UNITED STATES PATENT AND TRADEMARK OFFICE

Office Action Summary

10/706,392

MARUYAMA, KUNIYA

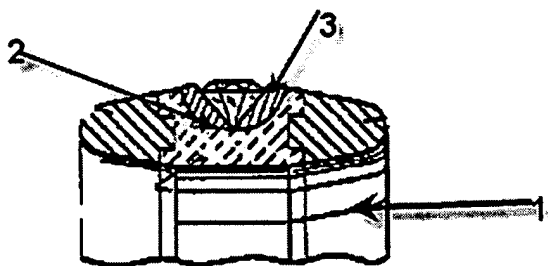
As for Claim 1, West teaches of an item of jewelry (see figure below) comprising a main body (1) having an inlay area of concaved shape (2), and a decorating part (3) secured in said inlay area (2), the improvement comprising said decorating part (3), said decorating part (3) being composed of precious metal components (col. 6, lines 28, and from Claim 1, “a precious metal disposed within said groove”), said decorating part (3) being secured in said inlay area (2) by a layer of solder (col. 6, line 30, “One way to affix precious metal to the part is to use a brazing process...”) in said inlay area (2) between said decorative part (3) and said main body (1).

The difference between the claim and West is that West does not expressly state that the composition of the decorative part (3) secured in the inlay area (2) of the main body (1)

Re: Claim 2, wherein said jewelry has a curved surface at said inlay area (2).

Re: Claim 3, wherein said jewelry is selected from a group of jewelry including rings (Fig. 2), pendants, necklaces, earrings, cuff buttons, brooches, tie tacks, bangles, buckles, chokers, bracelets, watch band and glasses.

As for Claim 8, West teaches of an item of jewelry (see figure above) comprising a main body (1) having an inlay area (2) of concaved shape and a decorating part (3) secured in said inlay area (2); said inlay area (2) comprising a main channel (1/2) and at least one groove extending from a side of said channel (1/2); said decorating part (3) being composed of a copper alloy which contains 6 to 15 percent copper and 94 to 85 percent gold (see above statement from claim 1); said decorative part (3) being secured in said inlay area (2) said decorating part (3) corresponding in shape to the shape of the inlay area (2) main channel (1/2); said decorating part (3) being deformable to fill said at least one groove upon the application of pressure to said decorating part (3).
